CV-mixed uses dev proposal

CITIZENS REVIEW AND CRITIC

EOBJECTIVES FOR STUDYING & AMENDING THE "CARLSBAD MIXED USE" DEVELOPMENT PROPOSAL July 2024

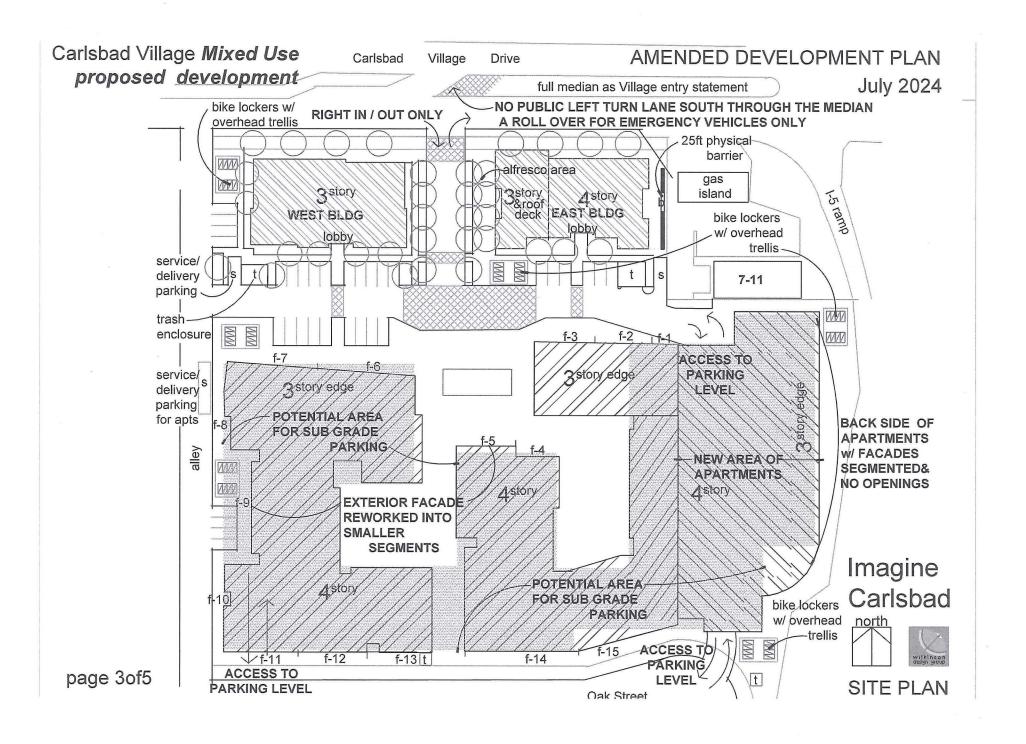
We believe the overall plan and design of this development proposal is totally off base. As such it will not become a new neighbor that will contribute in a positive way to Carlsbad's Village. Why would we approve this kind of development in this important neighborhood?

The apartment building's scale, height and massing are excessive, its exterior elevation's repetitiveness give it a machine generated stamped out, non human appearance that is antithetical to the character of our Village.

Its two commercial buildings on Carlsbad Village Drive are way off target for what the neighborhood's master plan should be requiring. That is a streetscene rich in character and appropriate in scale enhancing a "Main Street" appearance of true "Mixed Use" development. These two buildings are more fitting and typical in a suburban setting.

Beyond these physical and visual problems we also question the development's traffic circulation plan and see no allowance for bicycle use, parking or storage. Also we see no locations for oversized vehicle parking needed to service and make deliveries to both the commercial and residential uses.

The proposal's solution to auto parking far exceeds AB 2097. The height of the structure for parking is excessive and unacceptable. Its elevations are oppressive. The City must hold this proposal to the same standards set by the two previous apartment projects in this Village district, the Lofts and Hope Ave apartments. Each of these utilized a sub grade level for parking, this development must do the same. With that type of parking they will have an increased area to build additional housing units for an increased yield

We are preparing a study that will modify this proposal so it will be more appropriate for our Village, Where it will then become a welcome new neighbor.
